**List of Body Builders notified of FL788 Recall**

May 2019  
FL788A-O  
NHTSA #18V-582  
Transport Canada #2018-468  
REVISED NOTICE

## **Subject: FCCC Motorhome Chassis Rear PDMs**

**Models Affected: Specific Freightliner Custom Chassis X-Line chassis manufactured November 23, 2015, through June 29, 2018, and equipped with a certain PDM.**

**Fig. 2, PDM Components**

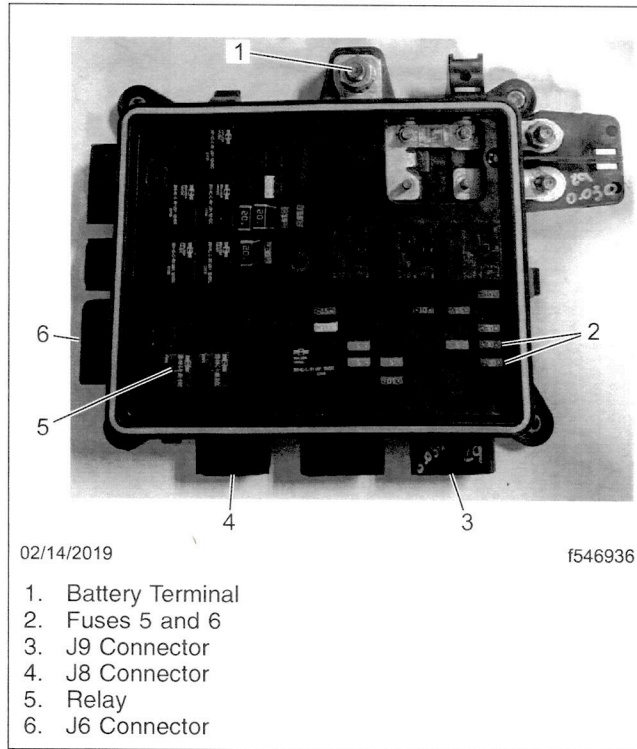
**REVISIONS:** The NHTSA number has been corrected to 18V-582, and the work instructions have been updated. On step 8 of the work instructions the probe locations have been corrected from F6 & F7 to F5 & F6 as well as fig. 2 has been updated to match the correct locations.

**REVISIONS:** The NHTSA number has been corrected to 18V-582, and the work instructions have been updated. On step 8 of the work instructions the probe locations have been corrected from F6 & F7 to F5 & F6 as well as fig. 2 has been updated to match the correct locations.
